Access Compliance Report

Public Rights-of-Way

Intersection ID: 43650	Main Street: CAMDEN_MEADOW_DR	Cross Street: BALLINDERRY_DR	Location: SW
ADA ID: 73AFCA648704	Ramp Type: PerpDiag	Initial Pass/Fail: Fail	Overall Compliance: No
		Severity Score: 12.5

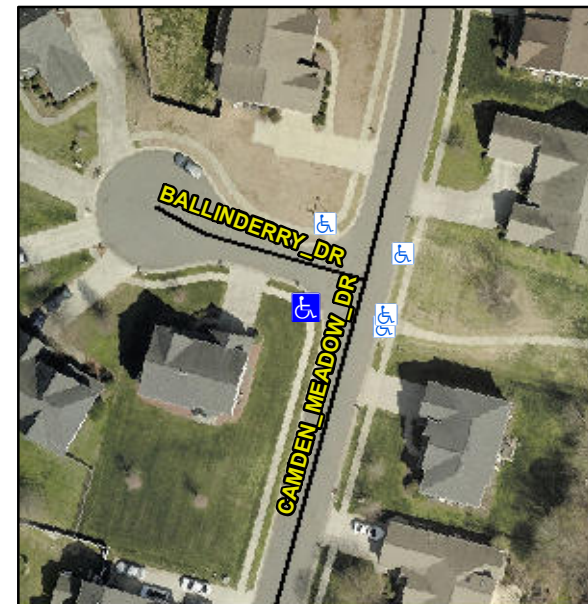
Not Found, R304.2.2

Compliance	Description	Data	Compliance	Description	Data
N/A	Ramp Length (in)	45.0	No	Ramp Slope (%)	9.9
Yes	Ramp Width (in)	51.0	Yes	Ramp XSlope (%)	1.1
N/A	Flare Type LT	N/A	N/A	Flare Type RT	N/A
N/A	Flare Slope LT (%)	N/A	N/A	Flare Slope RT (%)	N/A
N/A	Flare Traversable LT?	N/A	N/A	Flare Traversable RT?	N/A
N/A	Landing Length (in)	N/A	N/A	DWS Provided?	N/A
N/A	Landing Width (in)	N/A	N/A	DWS Contrast?	N/A
N/A	Landing Slope (%)	N/A	N/A	DWS Length (in)	N/A
N/A	Landing X Slope (%)	N/A	N/A	DWS Full Width?	N/A
N/A	Landing Curb? (Y/N)	N/A	N/A	DWS Offset (in)	N/A
N/A	Shared Landing?	N/A			
N/A	Gutter Ponding?	N/A	N/A	Gutter Slope (%)	N/A
N/A	Gutter Lip Ht (in)	N/A	N/A	Gutter X Slope (%)	N/A
N/A	Painted X Walk1?	No	N/A	Painted X Walk2?	No
	X Walk 1 Direction	To E		X Walk 2 Direction	To N
N/A	X Walk 1 Width (in)	N/A	N/A	X Walk 2 Width (in)	N/A
	X Walk 1 Slope (%)	4.1		X Walk 2 Slope (%)	2.2
	X Walk 1 X Slope (%)	1.0		X Walk 2 X Slope (%)	1.6

Remove & Replace Curb Ramp With Two New Directional Ramps or Equivalent.
